SPENT FUEL POOL FUEL ASSEMBLY STORAGE

ENVIRONMENTAL ASSESSMENT  
LICENSE AMENDMENT REQUEST (LAR) 90-0042

This proposed action involves the Davis-Besse Nuclear Power Station (DBNPS), Unit Number 1, Operating License Number NPF-3, Appendix A, Technical Specifications (TS). A license amendment is proposed to revise TS 3.9.13, Refueling Operations - Spent Fuel Pool Fuel Assembly Storage, associated TS Figure 3.9-1, Burnup versus Enrichment Curve for Davis-Besse Spent Fuel Storage Racks, and TS 5.6, Design Features - Fuel Storage. The proposed amendment would revise the provisions in the TS to allow storage of new and spent fuel assemblies with an initial nominal enrichment of uranium-235 no greater than 5.0 weight percent (wt%). The existing TS Figure 3.9-1 limits the initial enrichment of fuel that can be stored in the spent fuel pool to 3.8 wt%. The existing TS do not directly restrict the initial enrichment of new fuel that can be stored in the new fuel storage racks.

Figure 3.9-1  
 Burnup vs. Enrichment Curve for  
 Davis-Besse Spent Fuel Storage Racks

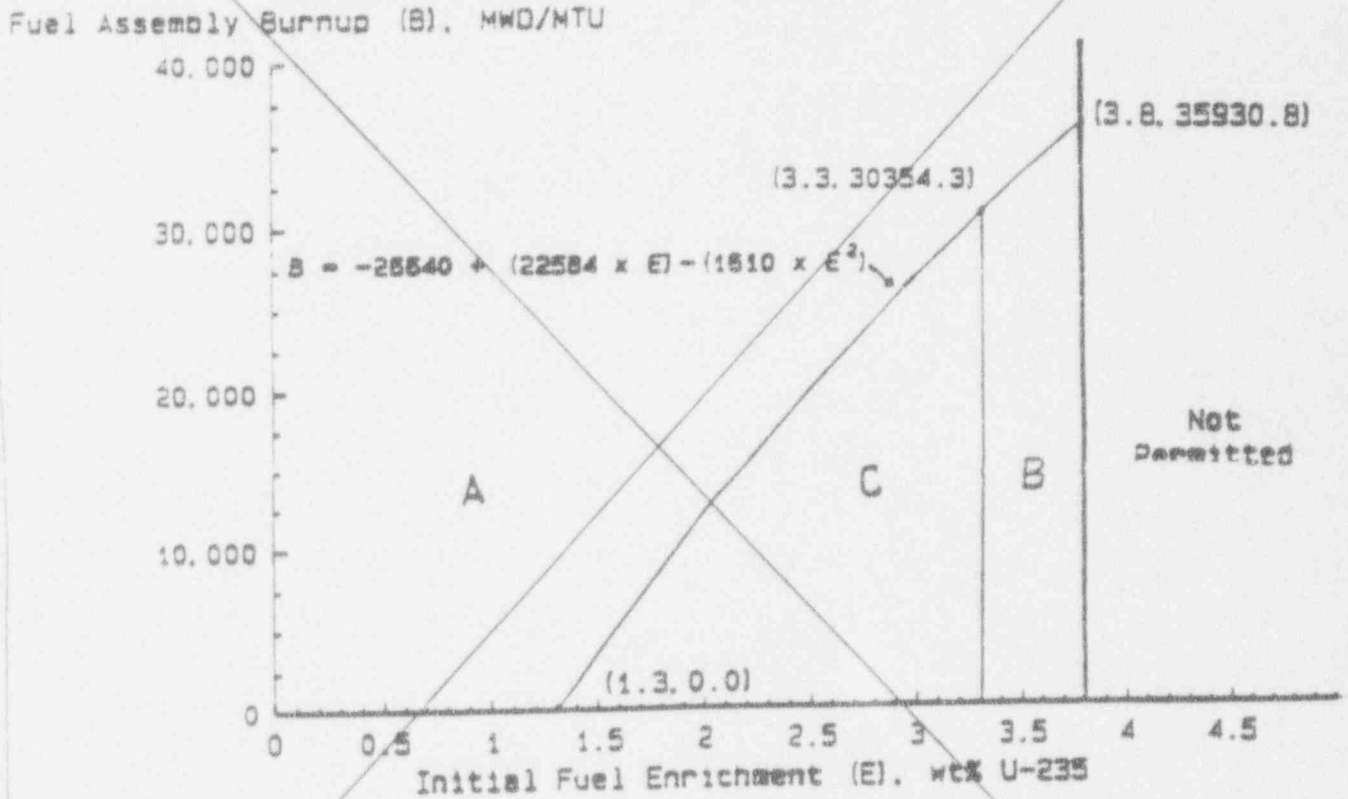
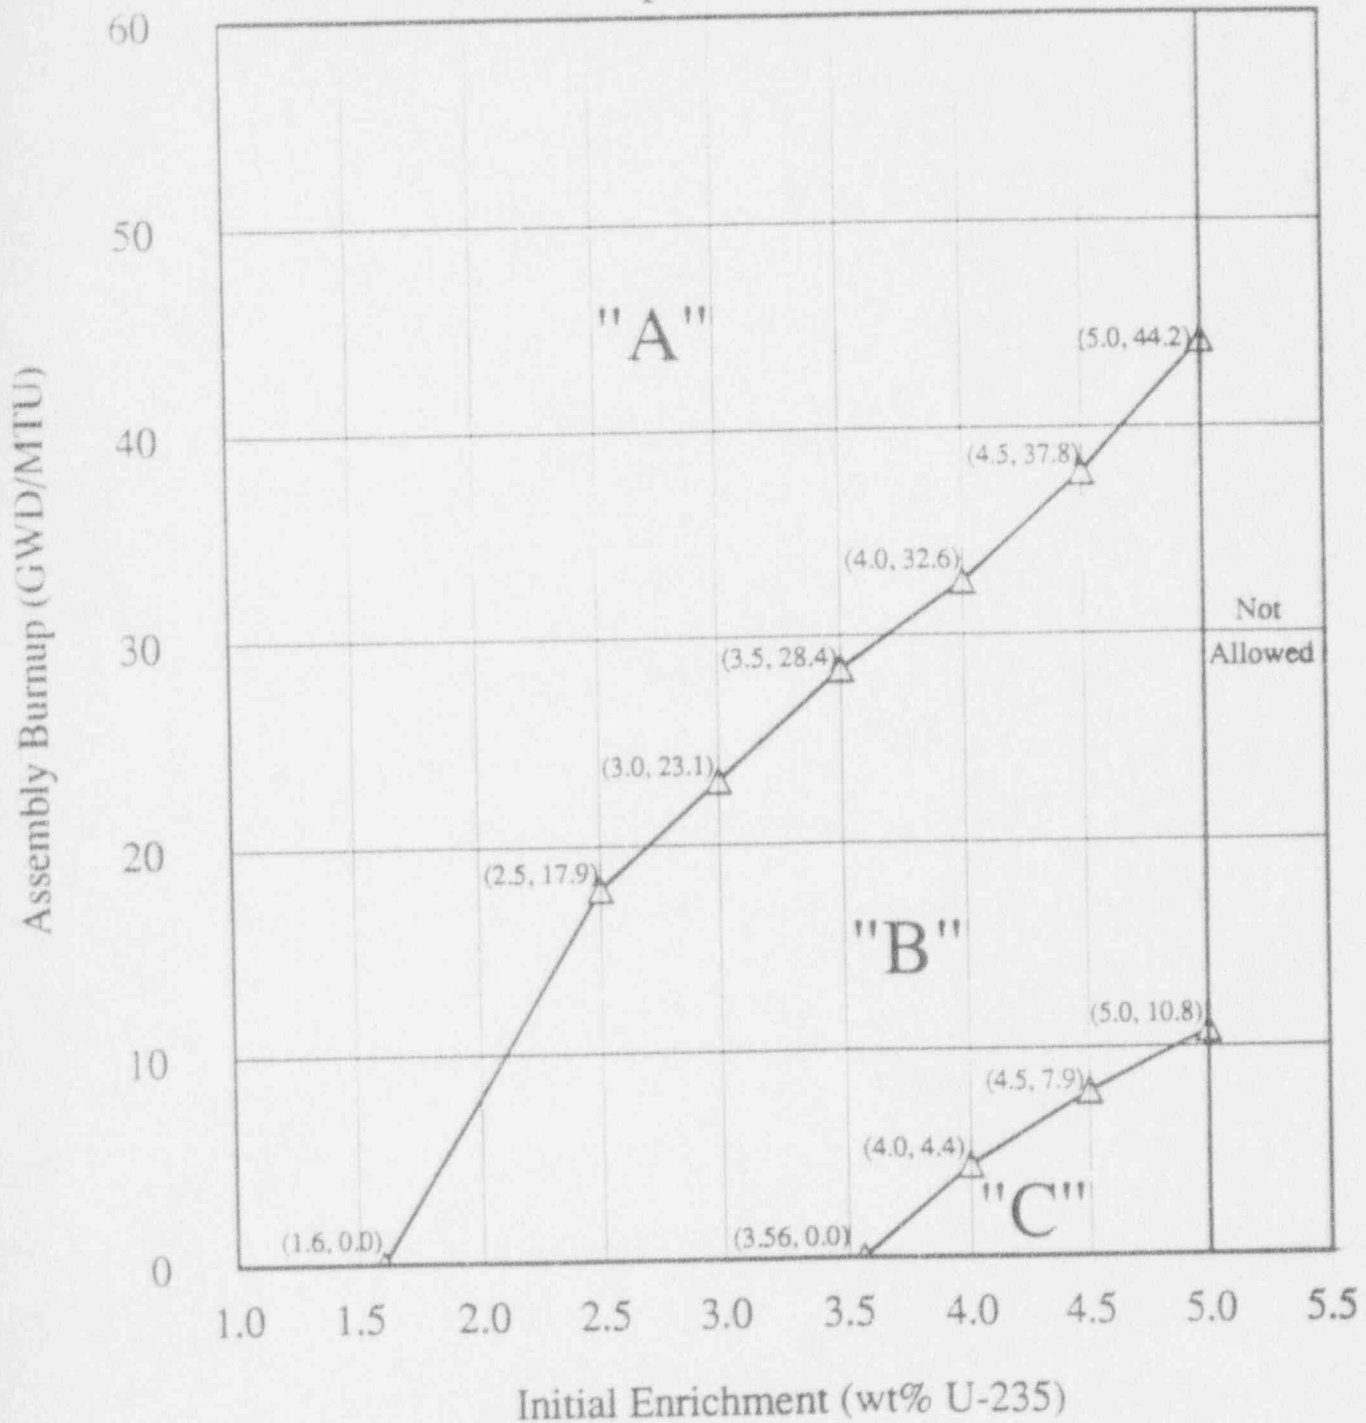
Replace with new Figure 3.9-1 (Attached)

Figure 3.9-1  
Burnup vs. Enrichment Curves For  
Davis-Besse Spent Fuel Storage Racks

Category "A": May be placed in any rack location

Category "B": Must not be placed directly adjacent to Category "C" assemblies

Category "C": May only be placed directly adjacent to Category "A" assemblies or non-fuel locations
